To: Regional Managers/Regional Engineers
From: Robert Ball, Technical Director 
CC: Gary Griggs, Frank Vacca, Scott Jarvis, Ben Tripousis, Diana Gomez, Michelle Boehm, Lisa Marie Alley, Boris Lipkin, Thierry Prate, Melissa Dumond, Mark McLoughlin, Lisa Nungesser, Ofelia Alcantara, Bruce Armistead, John Popoff, Simon Whitehorn, Dominique Rulens, HSR Environmental & Engineering Team Task Leads
Date: September 7, 2016
Subject: Notice to Designers No. 13 - Station Platform and Track Layout

STATION PLATFORM AND TRACK LAYOUT
 INTERMEDIATE STATION WITH HIGH-SPEED TURNOUTS
 (NOT APPLICABLE TO JOINT FACILITY AT LAUS AND 4TH/KING STATIONS)

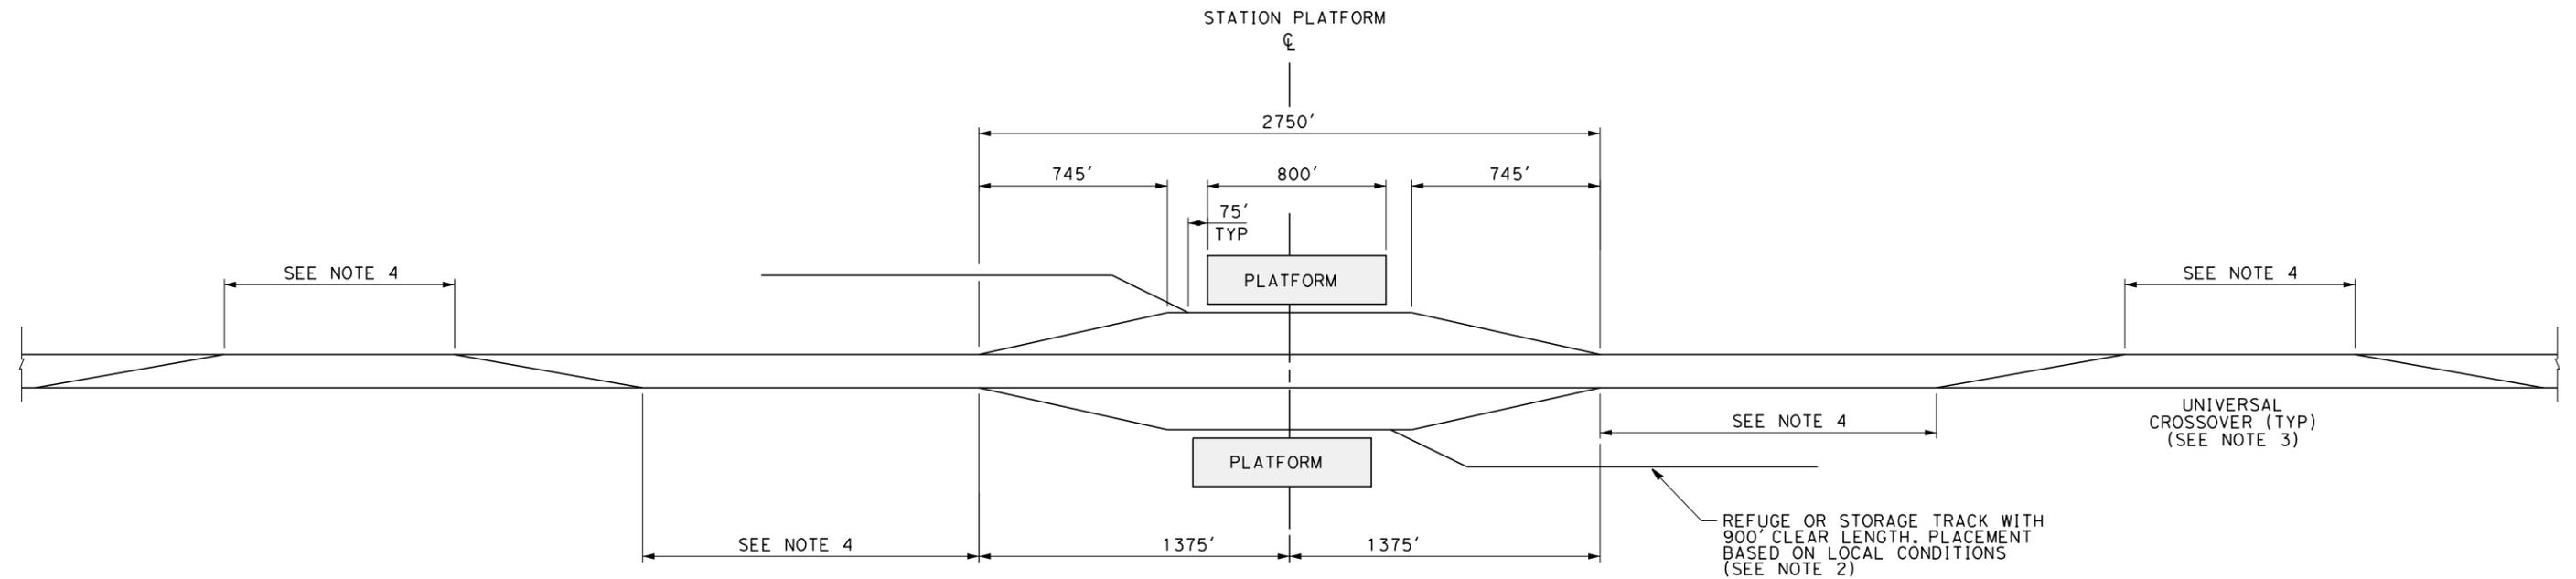
1. Modify the Usable Platform Length from 1,410 feet to 800 feet. Minimum and Exceptional values are omitted.
2. The station platform track between entry turnout and the exit turnout along the main track shall have a 2,750 foot minimum length centered symmetrically on the midpoint of the station platform.
3. Modify refuge track or storage track length from 1,650 feet to 900 feet clear length.

1. 60 MPH DESIGN SPEED FOR STATION TRACK TURNOUTS.
2. PROVIDE TWO REFUGE OR STORAGE TRACKS, EACH 900' MINIMUM. THE REFUGE OR STORAGE TRACK CAN BE LOCATED IN ANY QUADRANT OF THE STATION. EACH 900' REFUGE OR STORAGE TRACK IS PROVISIONAL WITH 50' SPACE FOR BUMPING POST AND SAFETY BUFFER ZONE AND 50' SPACE FOR RESCUE VEHICLES.
3. PROVIDE UNIVERSAL CROSSOVERS BETWEEN MAIN TRACKS AT EACH SIDE OF STATION TRACKS.
4. FOR POINT OF SWITCH SPACING, SEE NTD 10 "SPACING BETWEEN CROSSOVERS AND TURNOUT" DRAWING.
